ORCHARD GARDENS REDEVELOPMENT

DEVELOPMENT FOR:  
FIRST COMMUNITY HOUSING  
245 W.WEDDELL DRIVE, SUNNYVALE, CA 94089

100%  
CONSTRUCTION  
DOCUMENTS &  
PERMIT SUBMITTAL  
ISSUED ON:  
07.14.2025

Misc. Plan  
Permit -  
Substantial  
Conformance  
Documentation

**WEST ELEVATION - MISC. PLANNING PERMIT ADJUSTMENT DRAWING**

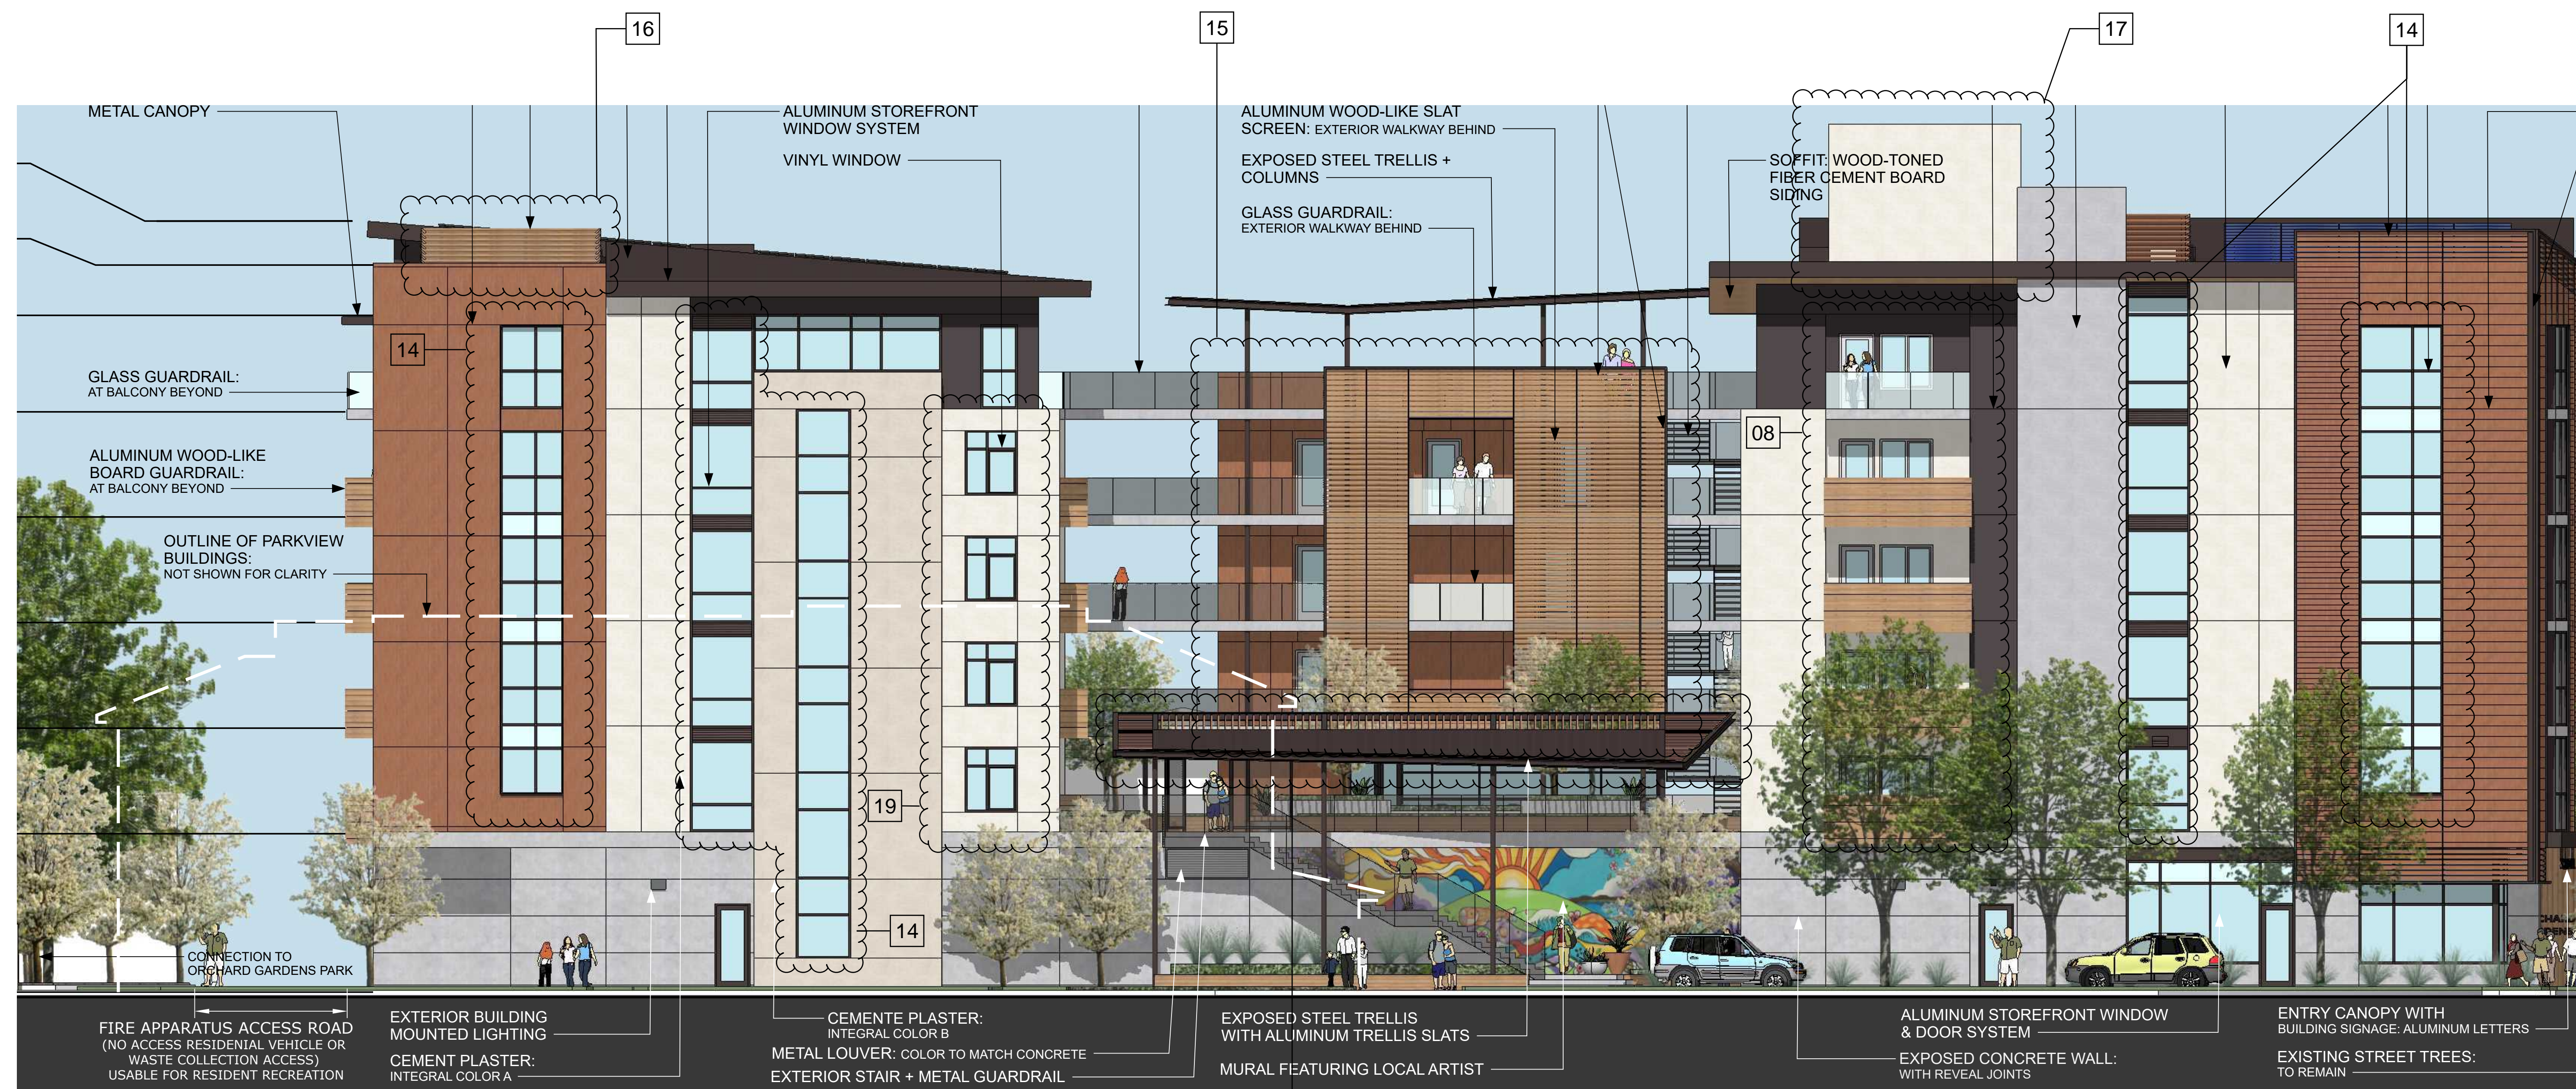
- |    |   |

| 08 | REMOVED ALL BALCONIES.  |
| 12 | REPLACE CENTRALIZED VRF SYSTEM WITH PTHP, PROVIDE NECESSARY LOUVERS       |
| 14 | REPLACE STOREFRONT AND WINDOW WALL WITH PUNCHED OPENINGS                  |
| 15 | *BUILDING B1 EXTERIOR FACADE UPDATED TO REFLECT COMMON ROOM RELOCATION.   |
| 16 | REMOVED VRF EQUIPMENT AND ROOF EQUIPMENT SCREEN ON BUILDING B2.           |
| 17 | ELEVATOR OVERRUN HEIGHT REDUCED TO 73'-6"                                 |
| 18 | REMOVAL OF STEEL CANOPY OVER EXTERIOR STAIR                               |
| 19 | WINDOW LITES AND MULLIONS SHIFTED TO MAINTAIN OSHA GUARDRAIL REQUIREMENTS |
| 20 | VERTICAL METAL PICKET GUARDRAIL   |

**G** VERTICAL METAL PICKET GUARDRAIL  
COLOR: ZINC GREY, TYPICAL

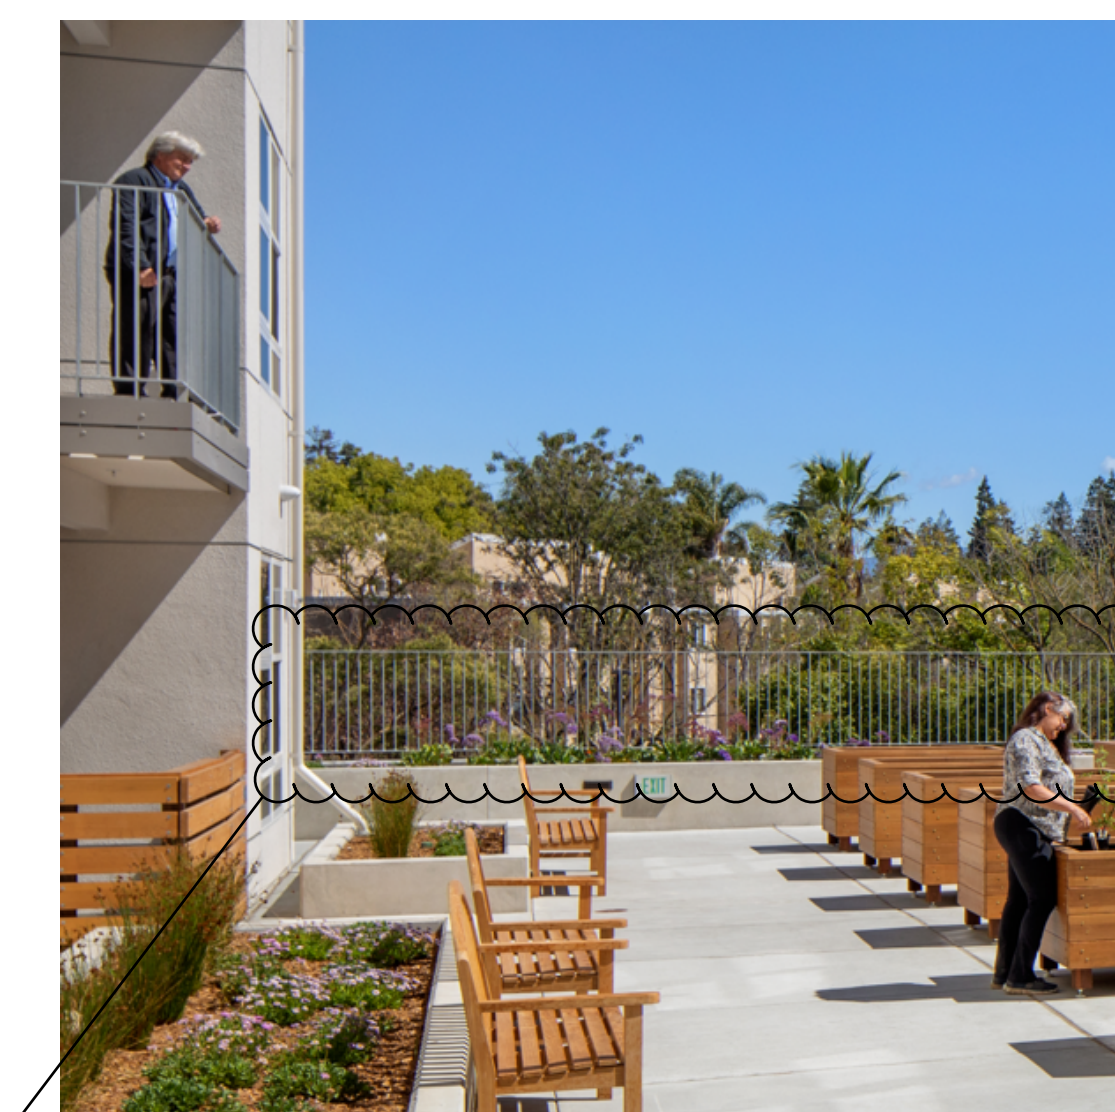
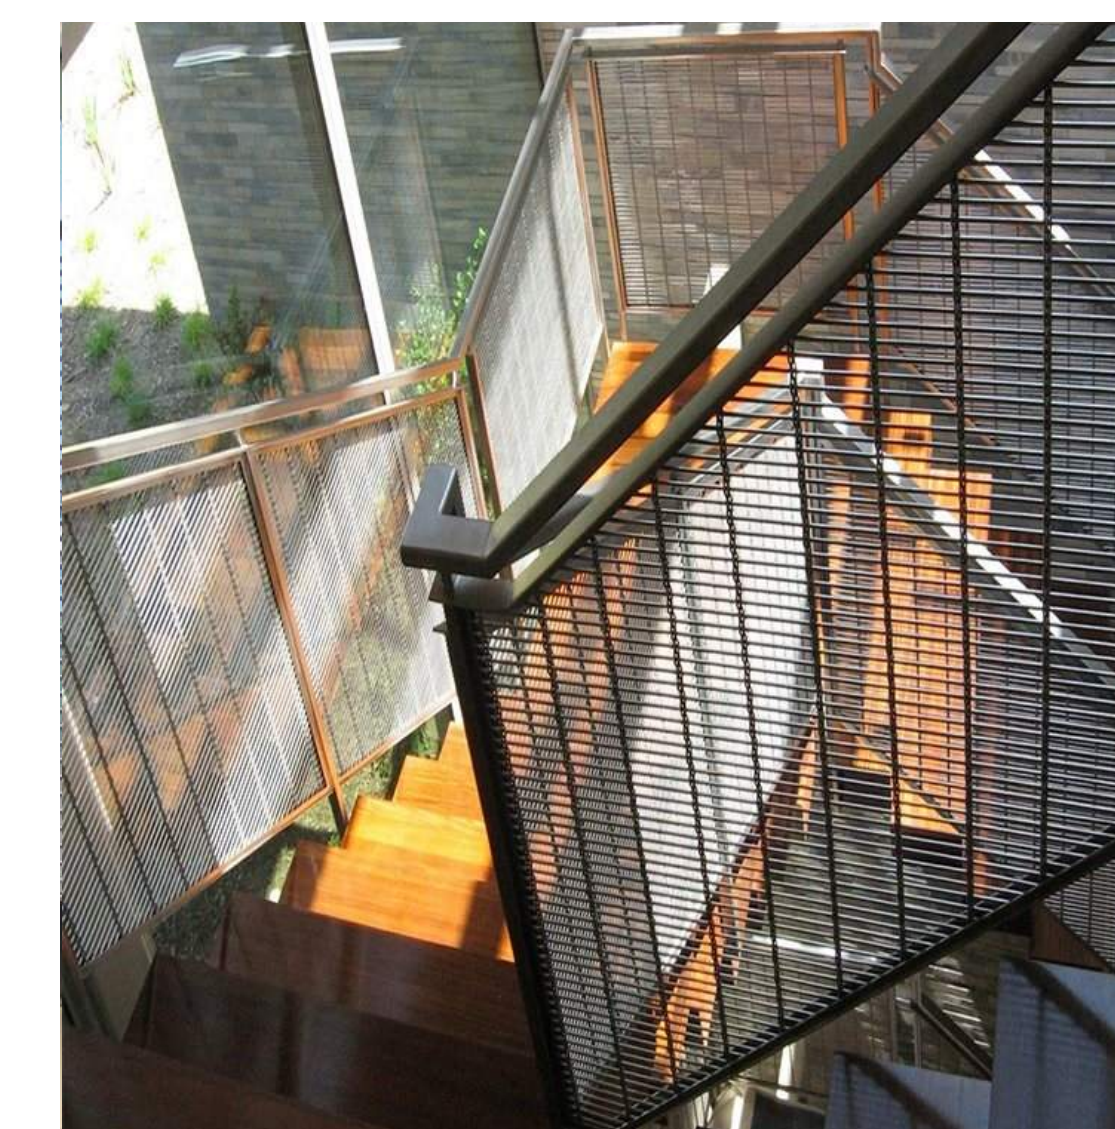
**G**  
METAL GUARDRAIL WITH FRAMED METAL MESH INFILL PANEL  
COLOR: ZINC GREY, TYPICAL;  
DARK ANODIZED BRONZE AT WESTERN EDGE OF COURTYARD
